# Access Compliance Report

## Public Rights-of-Way

Intersection ID: 51491	Main Street: N_TRYON_ST	Cross Street: INSTITUTE_CR	Location: S
ADA ID: 5138CE6FDC89	Ramp Type: Perp	Initial Pass/Fail: Fail	Overall Compliance: No
Severity Score: 21.25			
Codes/Mitigation Info/Possible Solution		Field Measurements/Component Compliance

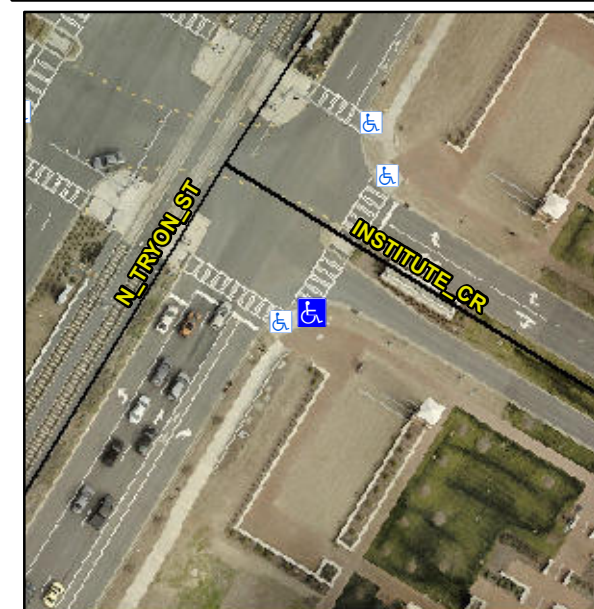
**Remove & Replace Entire Ramp.**

**R304.5.1, R304.5.3**

Compliance	Description	Data	Compliance	Description	Data
N/A	Ramp Length (in)	114.5	Yes	Ramp Slope (%)	5.0
No	Ramp Width (in)	47.5	No	Ramp XSlope (%)	5.3
N/A	Flare Type LT	N/A	N/A	Flare Type RT	N/A
N/A	Flare Slope LT (%)	N/A	N/A	Flare Slope RT (%)	N/A
N/A	Flare Traversable LT?	N/A	N/A	Flare Traversable RT?	N/A
N/A	Landing Length (in)	N/A	N/A	DWS Provided?	N/A
N/A	Landing Width (in)	N/A	N/A	DWS Contrast?	N/A
N/A	Landing Slope (%)	N/A	N/A	DWS Length (in)	N/A
N/A	Landing X Slope (%)	N/A	N/A	DWS Full Width?	N/A
N/A	Landing Curb? (Y/N)	N/A	N/A	DWS Offset (in)	N/A
N/A	Shared Landing?	N/A			
N/A	Gutter Ponding?	N/A	N/A	Gutter Slope (%)	N/A
N/A	Gutter Lip Ht (in)	2.0	N/A	Gutter X Slope (%)	N/A
N/A	Painted X Walk1?	No	N/A	Painted X Walk2?	N/A
	X Walk 1 Direction	To NE		X Walk 2 Direction	N/A
N/A	X Walk 1 Width (in)	N/A	N/A	X Walk 2 Width (in)	N/A
	X Walk 1 Slope (%)	3.4		X Walk 2 Slope (%)	N/A
	X Walk 1 X Slope (%)	6.8		X Walk 2 X Slope (%)	N/A
